SUBJECT: DEMONSTRATION / DELIVERY HOLD: Safety Recall 07S50:
Certain 2008 F-250/350/450/550 Vehicles Equipped with a 6.4L Diesel Engine
Battery Cable Inspection and Adjustment

CERTAIN 2008 F-250/350/450/550 VEHICLES EQUIPPED WITH A 6.4L DIESEL ENGINE – BATTERY CABLE INSPECTION AND ADJUSTMENT

FIGURE 1

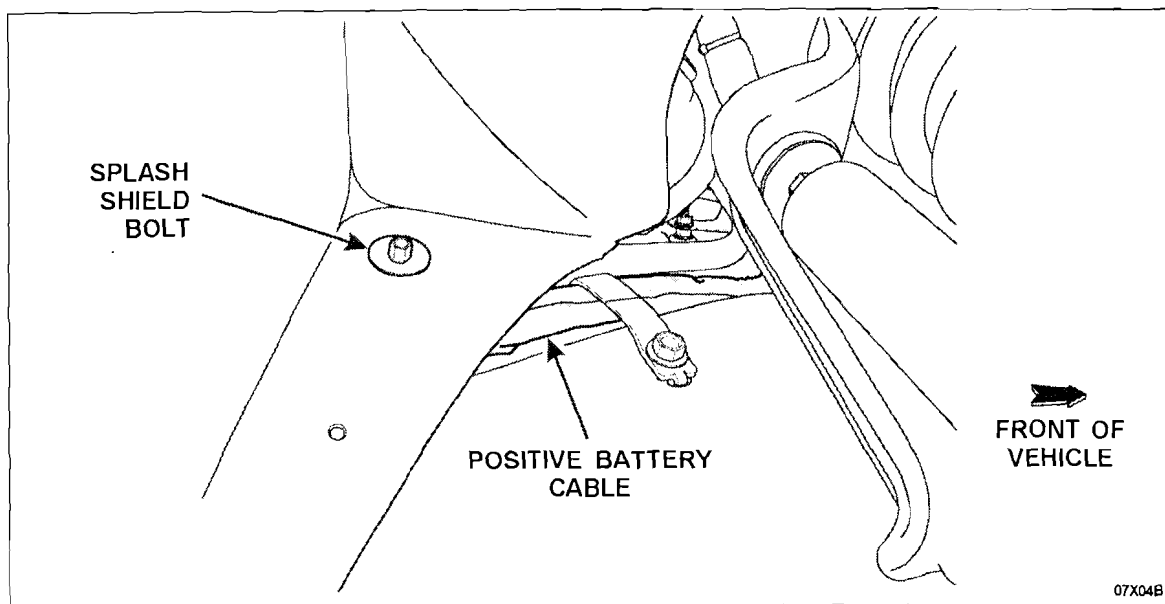
1. Place the vehicle on hoist.
2. Verify that there is at least 15 mm (5/8 in) of clearance between the positive battery cable and the splash shield bolt by placing your hand between them. See Figure 1

FIGURE 2

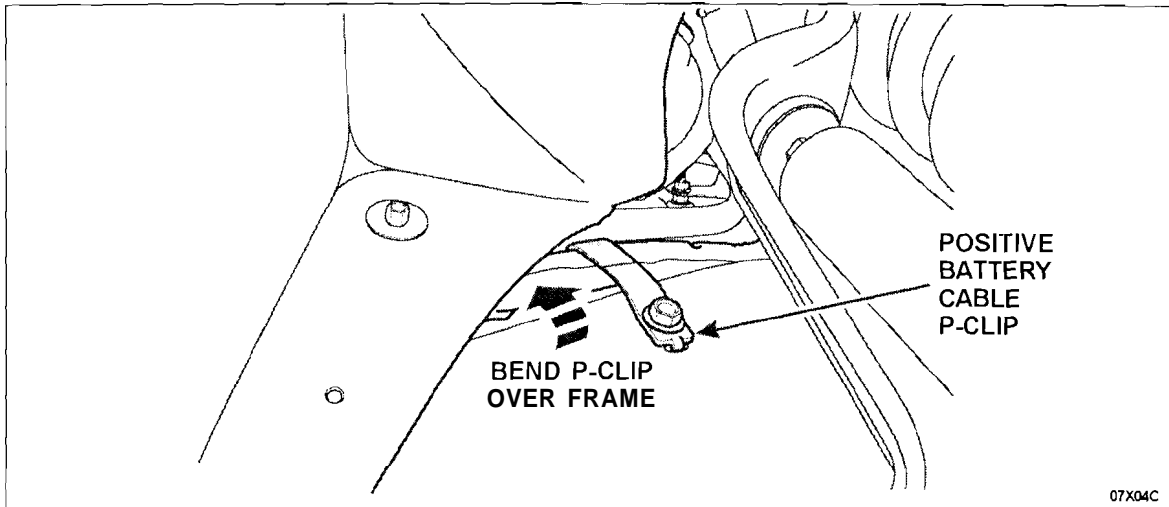
3. If you are unable to fit your hand between the splash shield bolt and the positive battery cable (at least 15 mm [5/8 in]), bend the P-clip over the frame and recheck for clearance. See Figure 2.

FIGURE 3

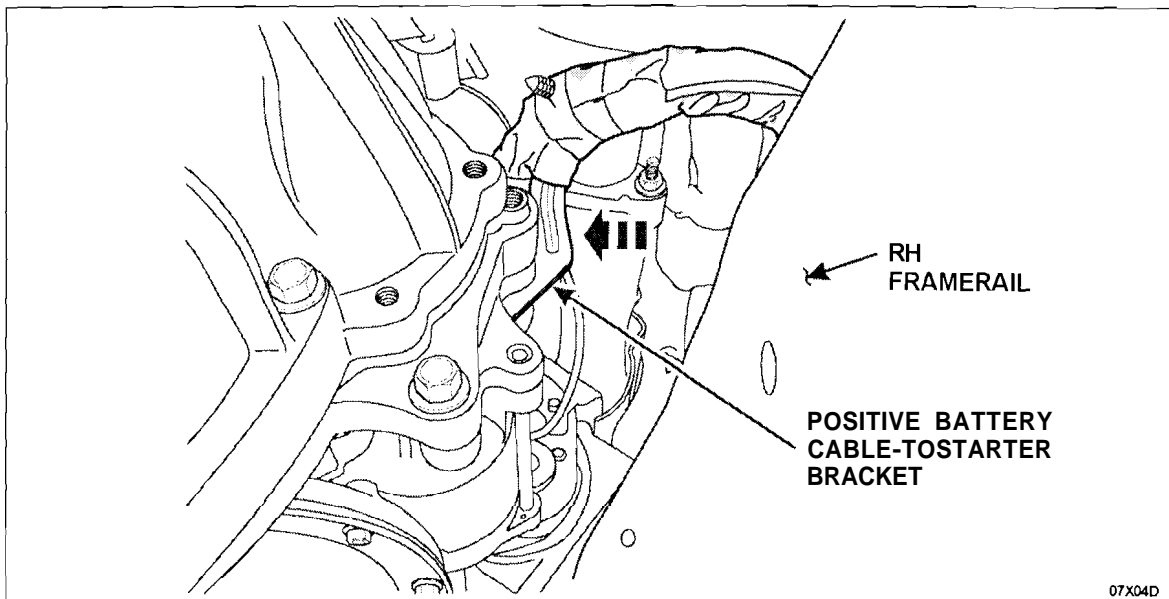
4. If still unable to fit your hand between the splash shield bolt and the positive battery cable (at least 15 mm [5/8 in] clearance), then pull the cable towards the engine to bend the positive battery cable-to-starter bracket to create the necessary clearance (at least 15 mm [5/8 in]). Then verify the clearance between the splash shield bolt and the positive battery cable. See Figure 3.
